**THE MARYLAND-NATIONAL CAPITAL PARK AND  
PLANNING COMMISSION**

**MEMORANDUM**

SUBJECT: Preliminary Plan 120060270  
Burton Woods – Phase I

**Burton Woods**

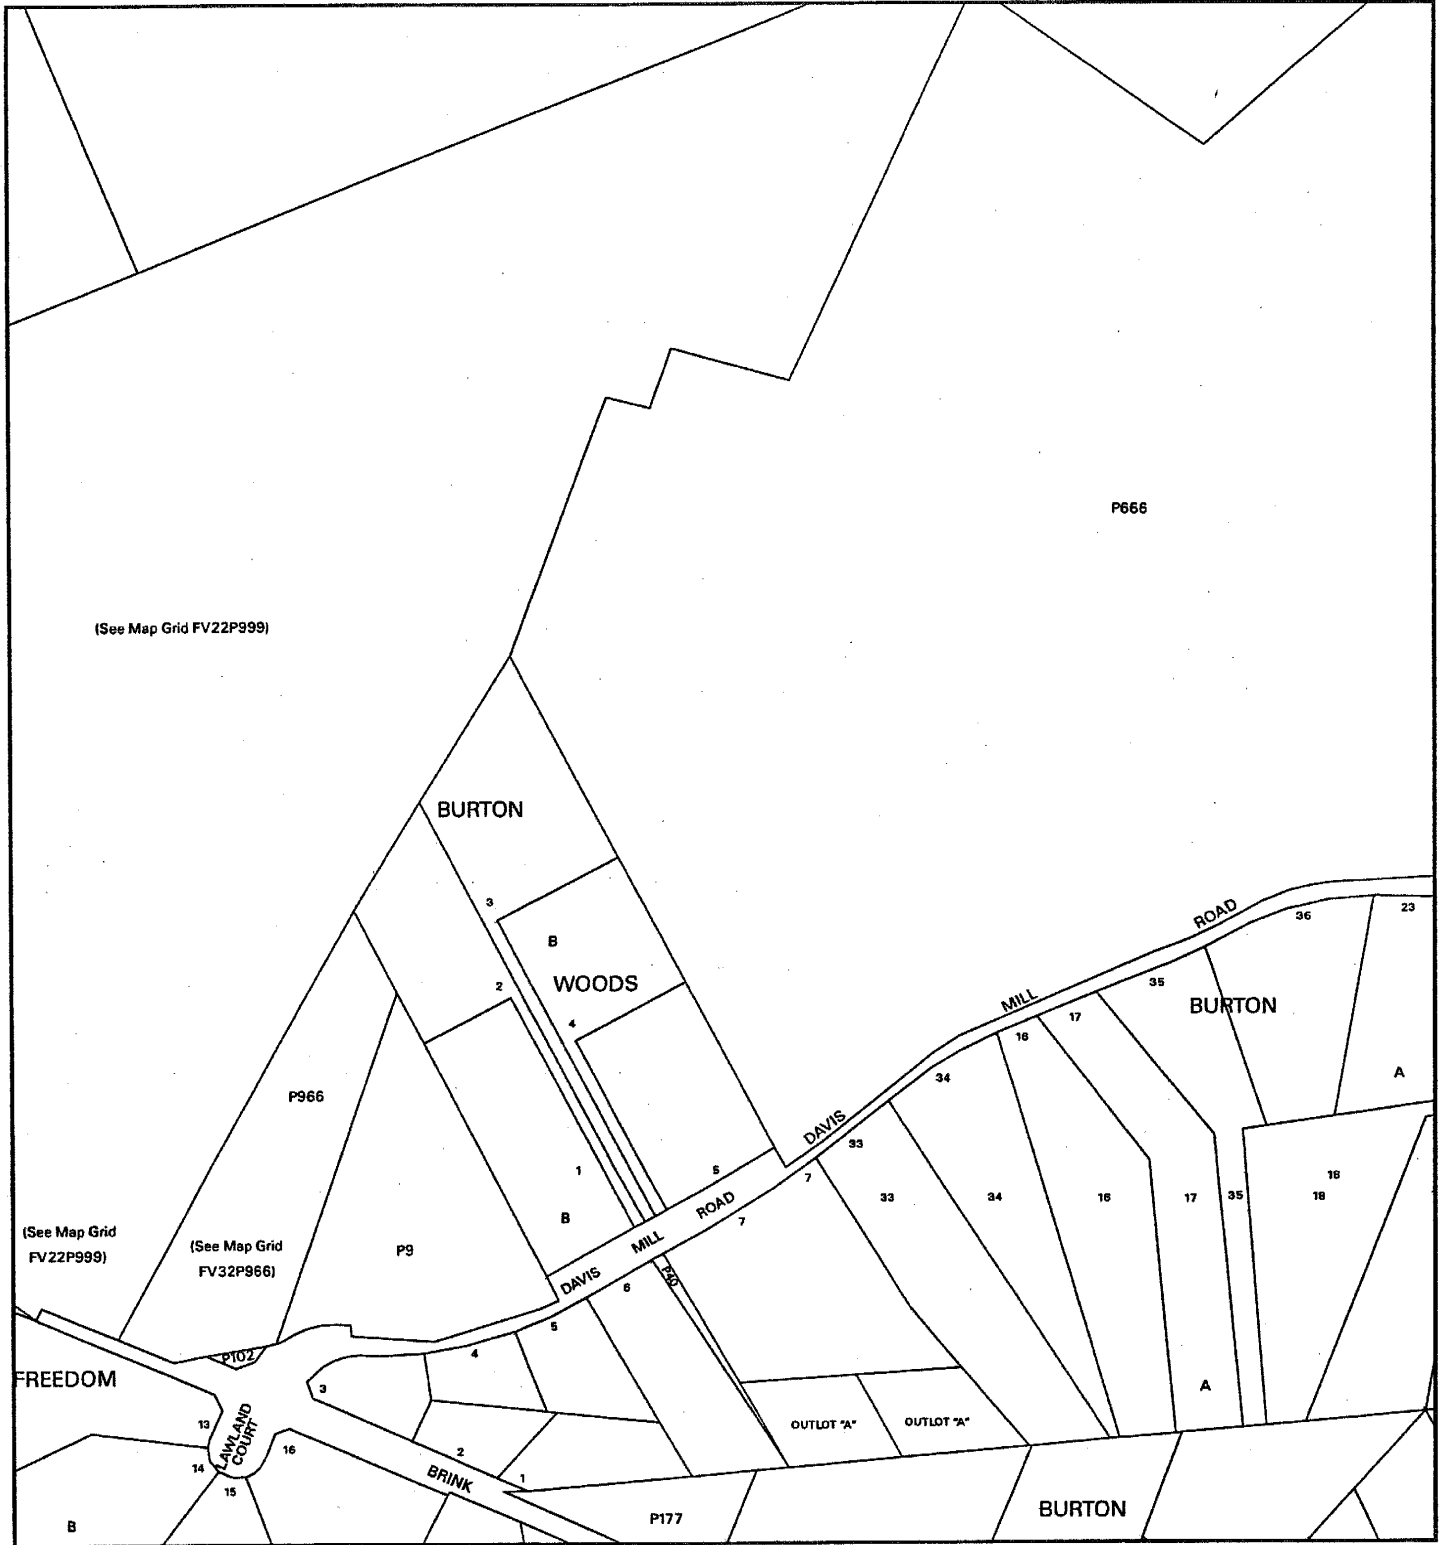
- Sight distance for driveway
- Davis Mill Road is a rustic road. Coordinate with DPS Rustic Roads Coordinator, Sarah Navid at 240-777-6307.
